## Product Change Notice (PCN)

**PCN Number: PCN-0451070R-01**

Product(s) Affected: PJ-028-SMT-TR, PJ-071, PJ-029-SMT-TR

Right

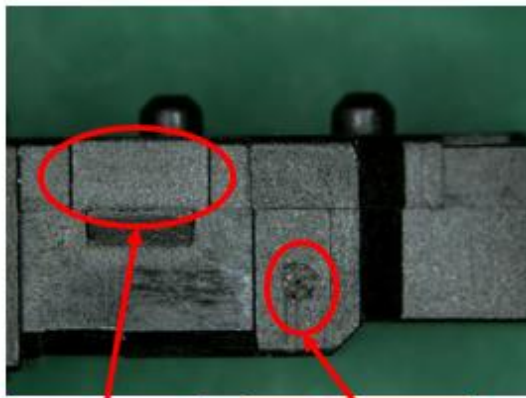
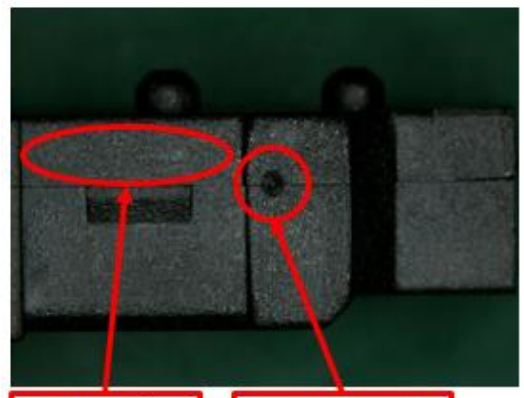
with mark

injection point

no mark

injection point

Top

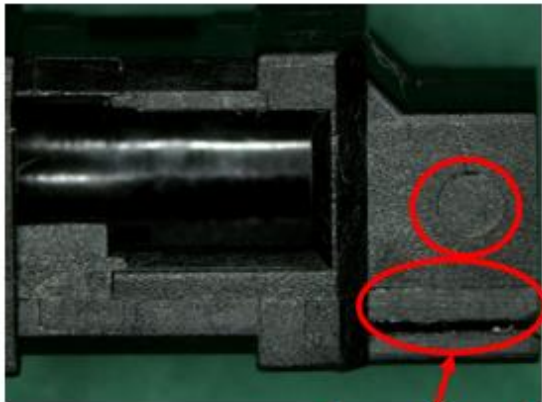
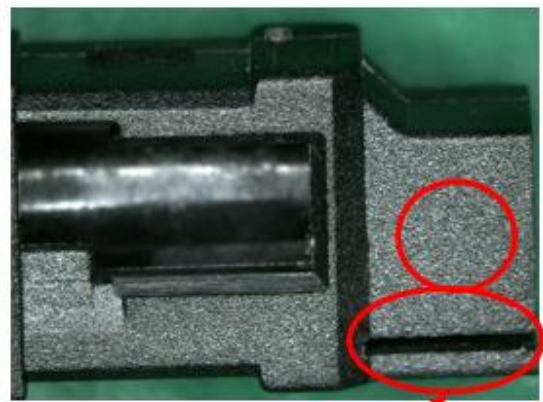
with mark

no mark

Bottom

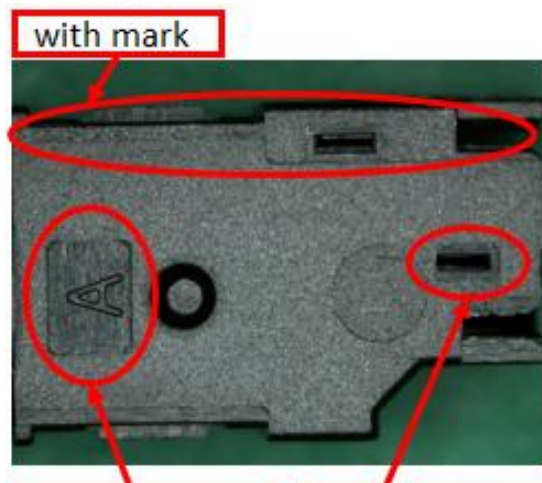
with mark

outlook different

mark position

no mark

outlook different

mark position
